**ADDENDUM NO. 01 – PORTAGE PUBLIC SCHOOLS – HAVERHILL ELEMENTARY SCHOOL BP 5:  
FOOTINGS AND FOUNDATIONS**

## ADDENDUM NO. 1 [BP 5]

<b>DATE OF ISSUANCE:</b>	June 15, 2023
<b>PROJECT:</b>	<b>Haverhill Elementary School Bid Package 5: Footings and Foundations</b> 6633 Haverhill Avenue Portage, MI 49024
<b>OWNER:</b>	Portage Public Schools
<b>ARCHITECT'S PROJECT NO.:</b>	21-237.25
<b>ORIGINAL BID ISSUE DATE:</b>	May 25, 2023

**5 REBAR OFFSET AND LAP SPLICE CMU f' m=2000 PSI**  
 1" = 1'-0"

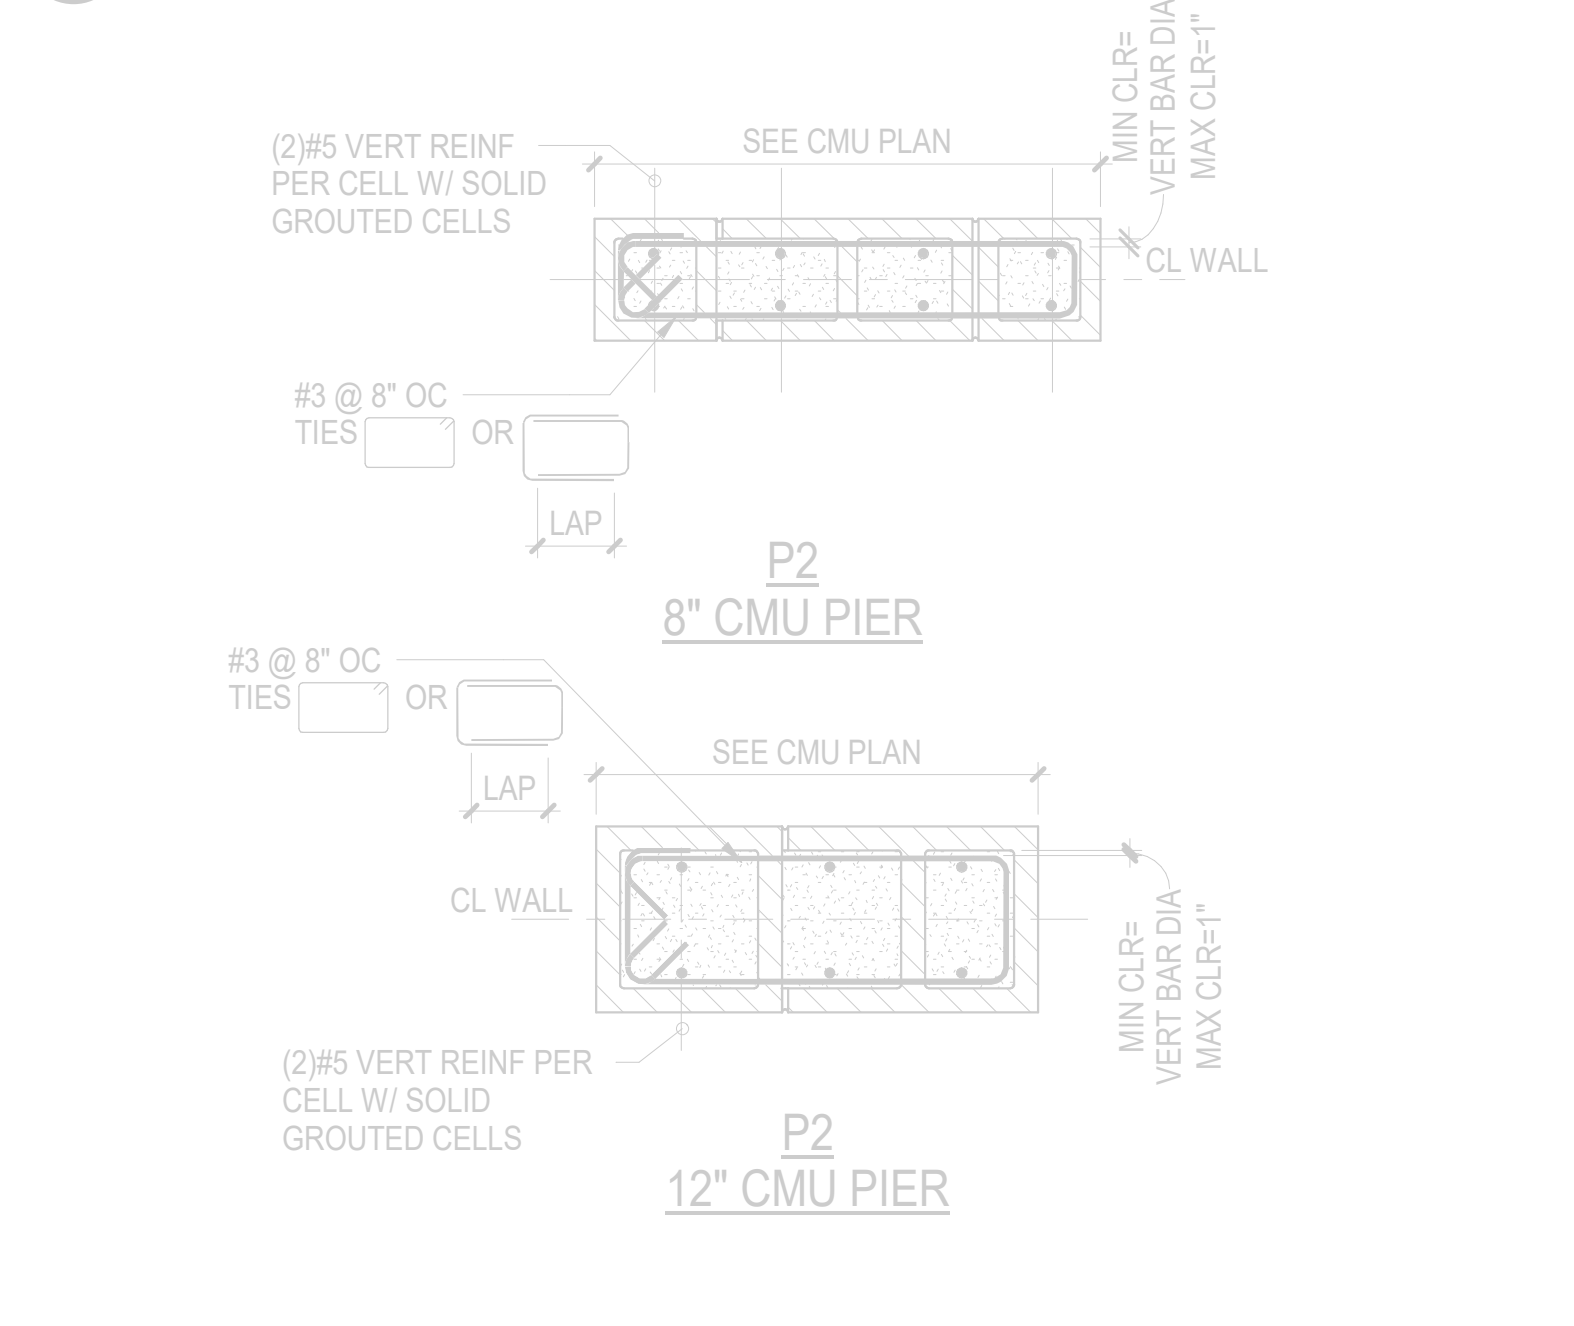
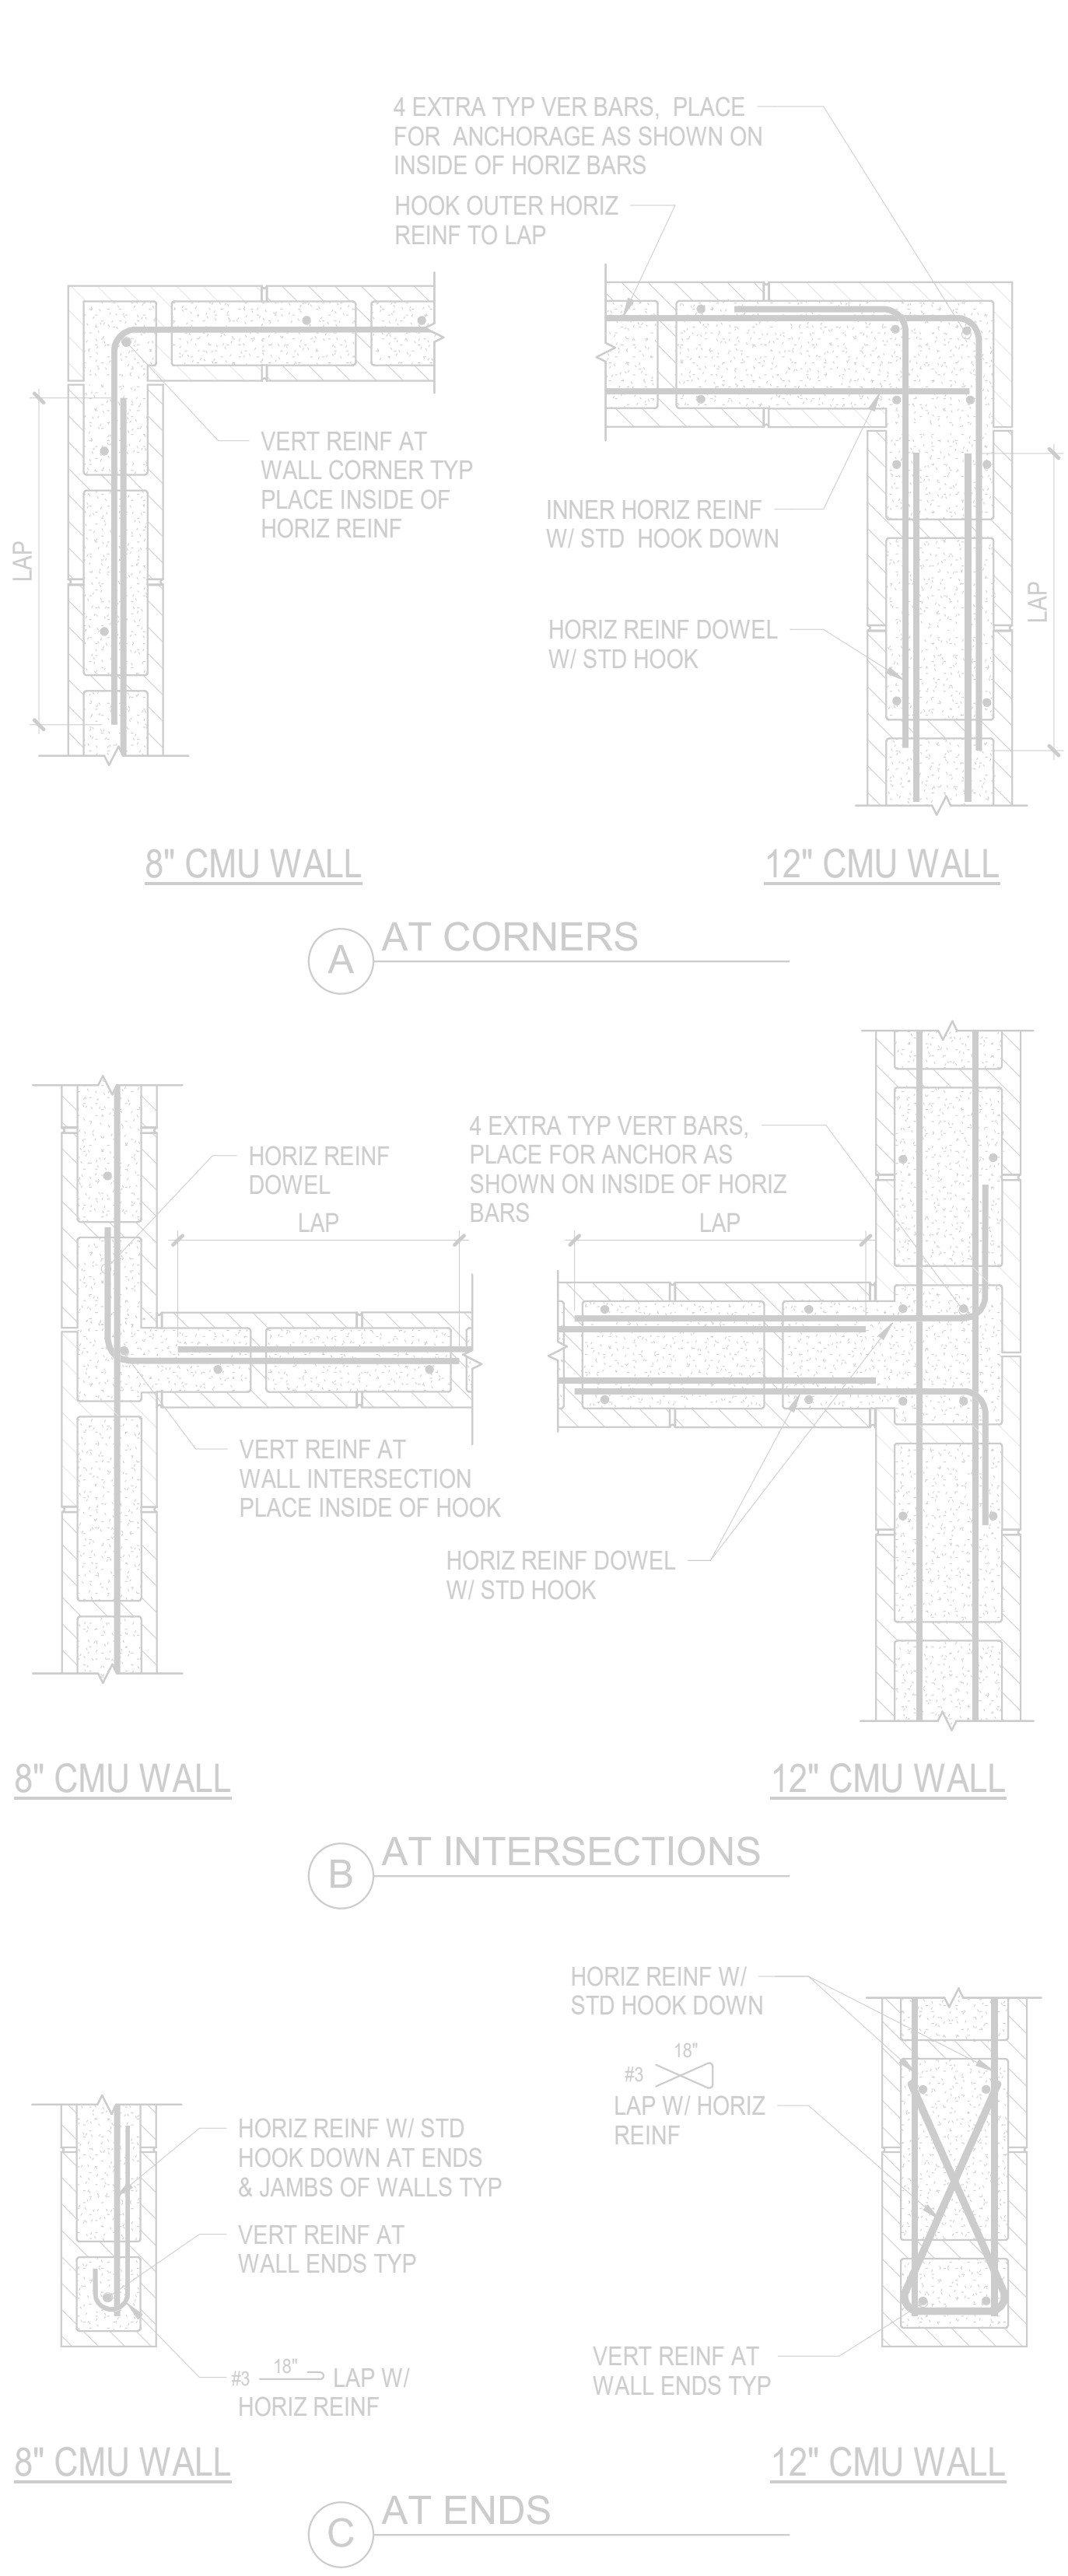
Refer to Sheet(s): S600 [for reference only]

- Clarified CMU wall type and reinforcement schedule

SHEET NUMBER  
**A 101**  
 21-237.20

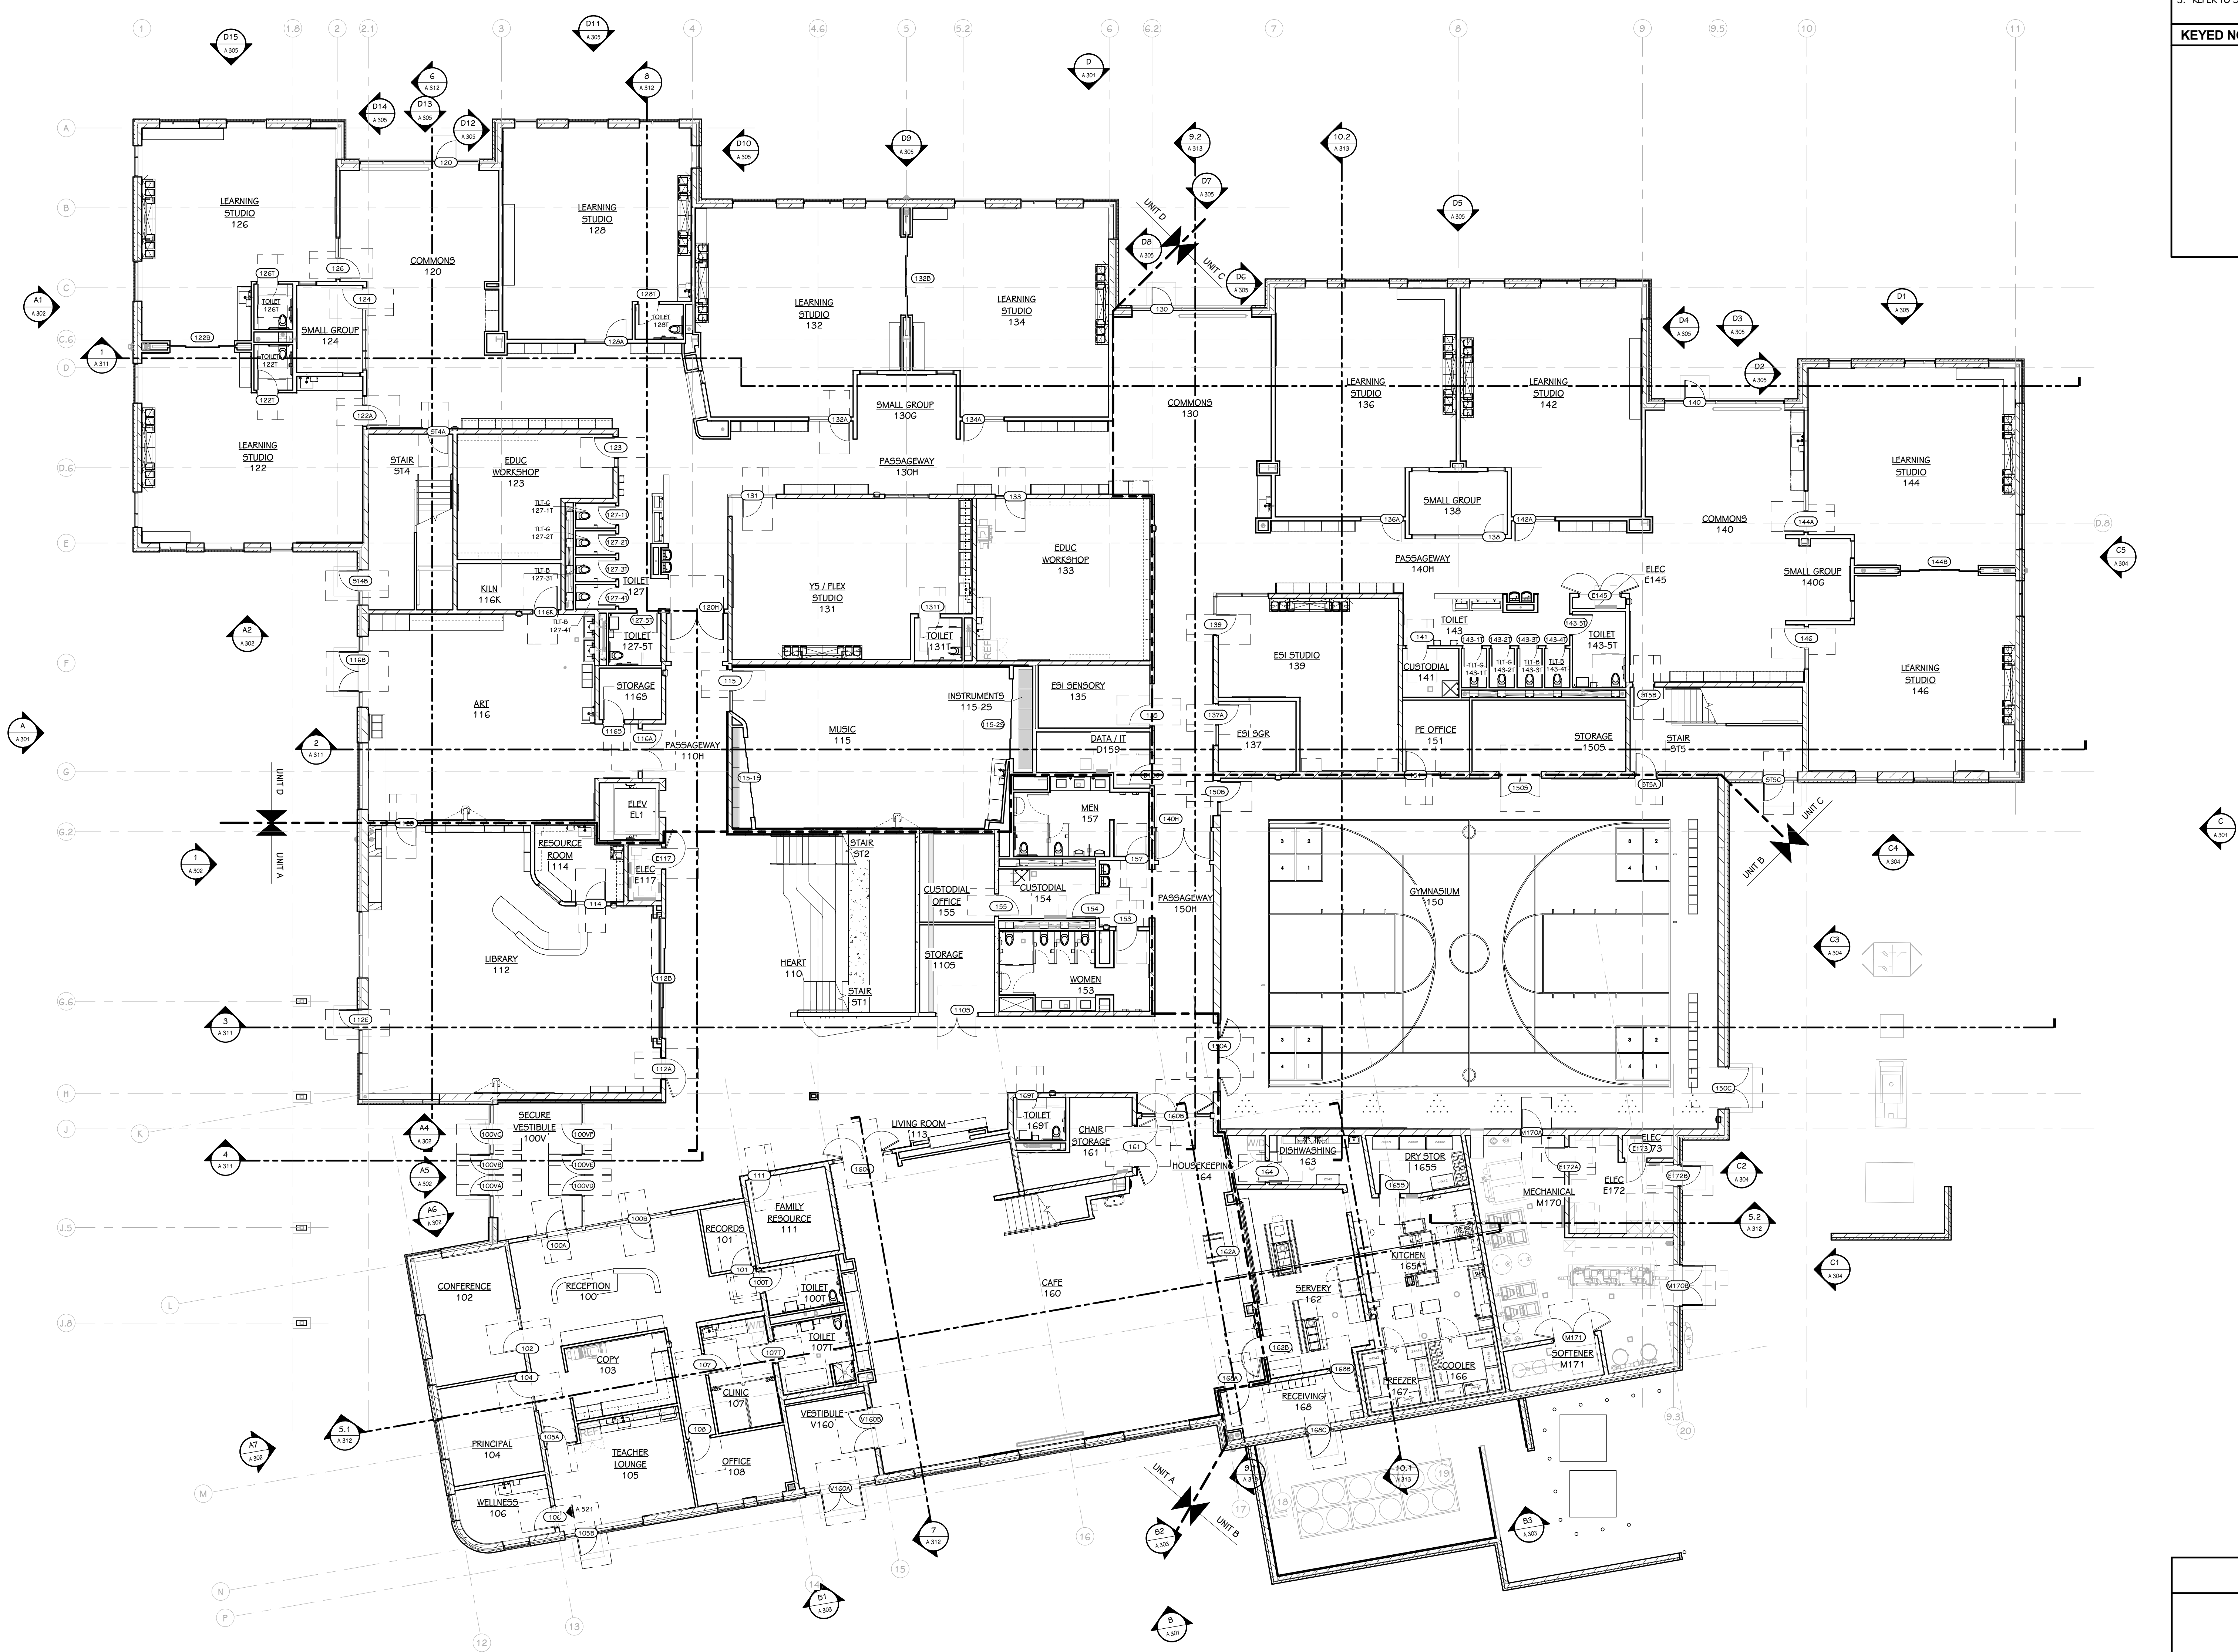
Refer to Sheet(s): G003, A101, A101A, A101B, A101C, A101D

Preliminary architectural first floor plans and interior partition sheet provided for wall widths.
